AMENDMENT CHANGES

ISSUE/REVISION	DATE	NO.
GDP CITY RESPONSE #1 R1	8/21/2025	
GDP CITY RESPONSE #1	7/18/2025	
GDP AMENDMENT	5/2/2025

CENTURA HEALTH

1 OF 1

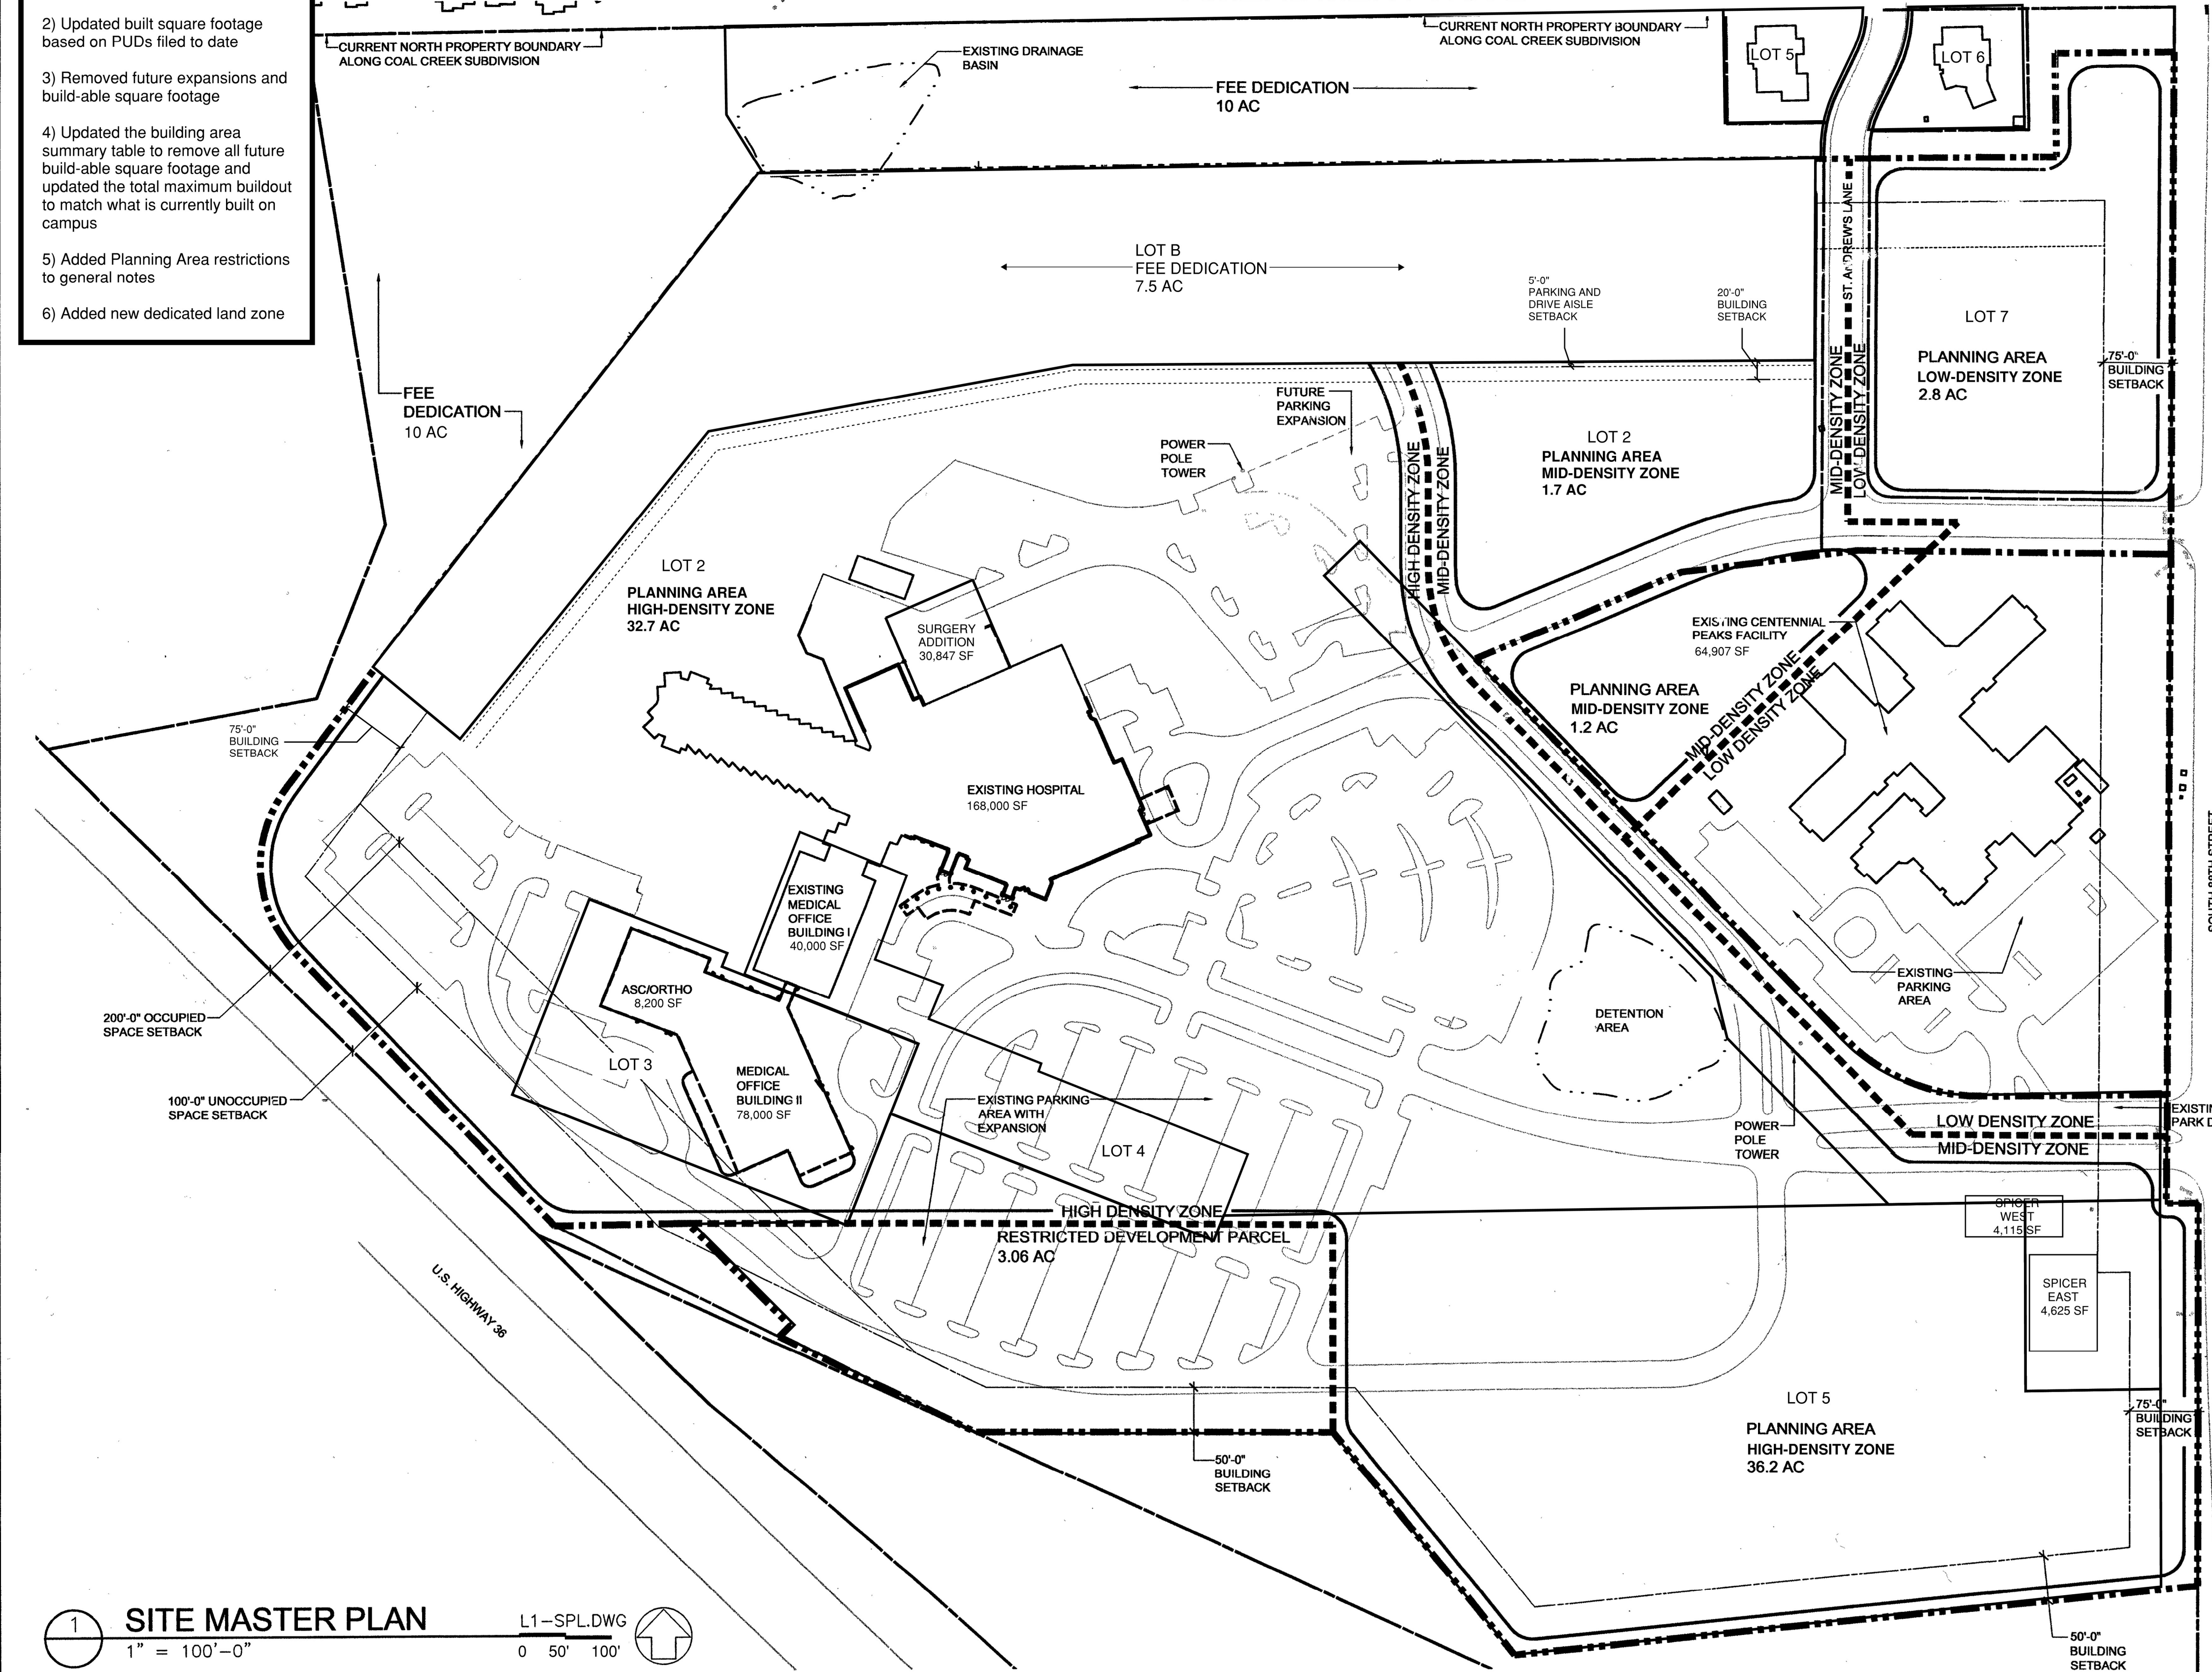
- 1) Updated planning areas to better align with the platted boundaries based on the Health Park Subdivision Filling 6 Final Plat
- 2) Updated built square footage based on PUDs filed to date
- 3) Removed future expansions and build-able square footage
- 4) Updated the building area summary table to remove all future build-able square footage and updated the total maximum buildout to match what is currently built on campus
- 5) Added Planning Area restrictions to general notes
- 6) Added new dedicated land zone
